**City of Urbandale  
Supplemental Specifications  
To Iowa Statewide Urban Standard  
Specifications for Public Improvements –2019 Edition  
January 2019**

URBANDALE STANDARD SPECIFICATIONS	REVISION 04-29-16
	<b>7030.101</b>	SHEET 1 of 1
<b>CONCRETE DRIVEWAY, TYPE A EXISTING PAVING, CURB GRINDING</b>

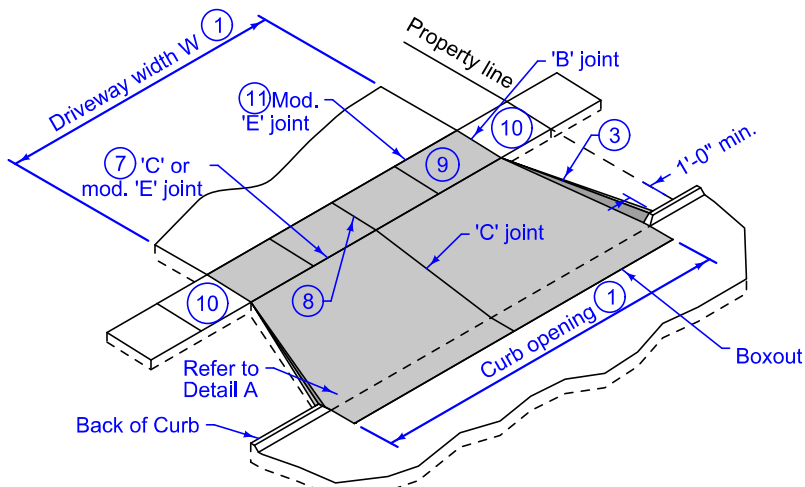
THIS DETAIL ONLY TO BE USED WITH PRIOR APPROVAL FROM CITY OF URBANDALE ENGINEERING DEPARTMENT.

URBANDALE STANDARD SPECIFICATIONS	REVISION 04-29-16 <b>7030.102</b>
	SHEET 1 of 1

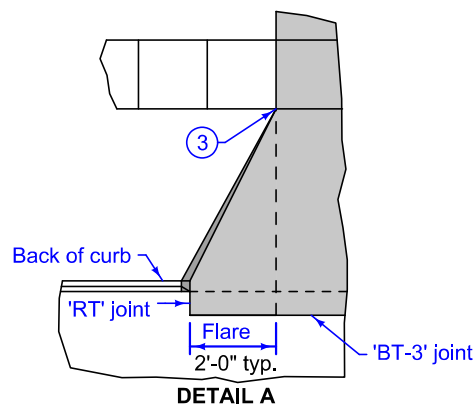
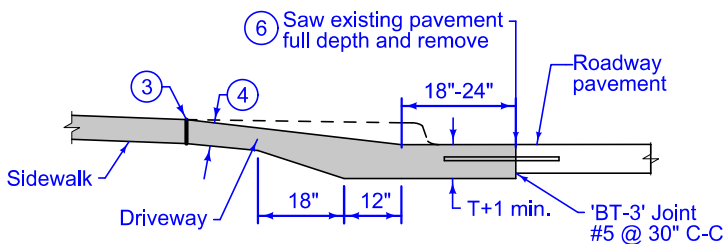
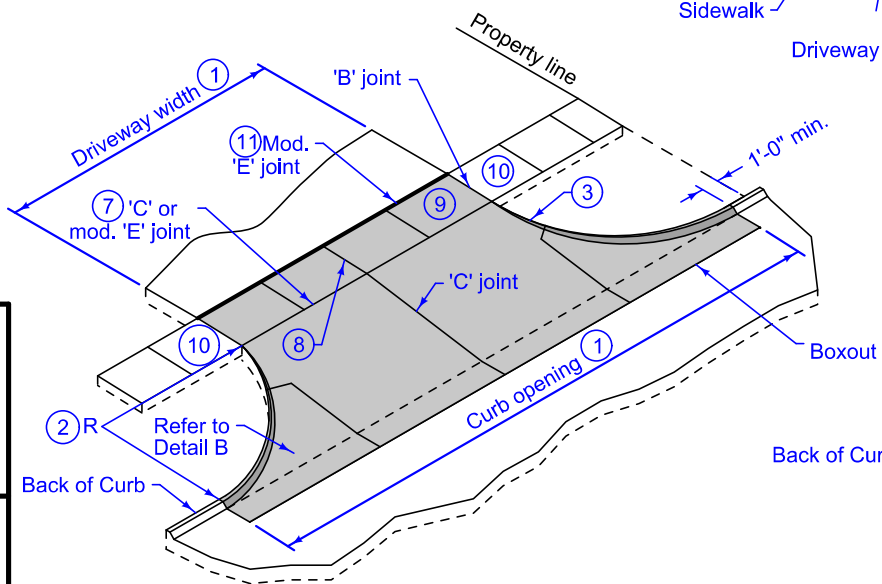
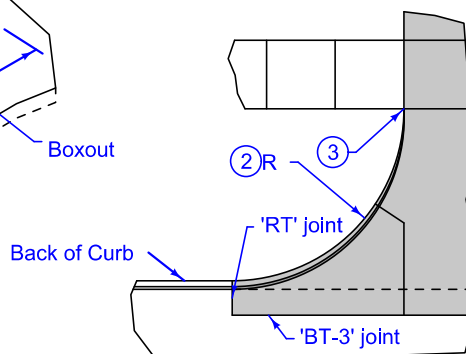
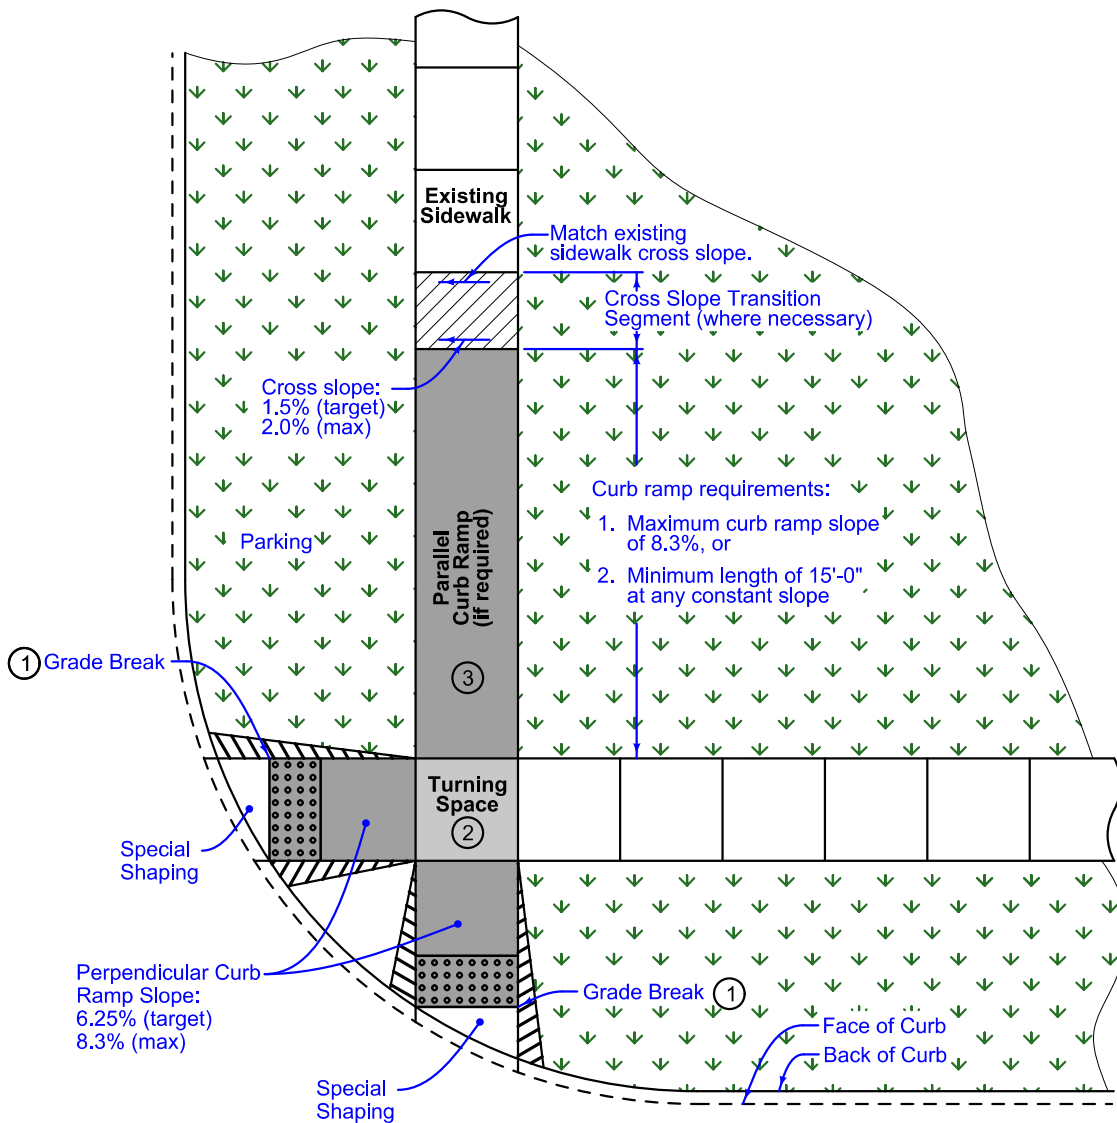
- ⑥ If longitudinal joint is located 48 inches or less from the back of curb, extend boxout to joint line. Full depth saw cut is still required.
- ⑦ Provide 'C' joint when sidewalk and drive approach are both being built. Provide 1/2" 'E' joint when sidewalk is existing.
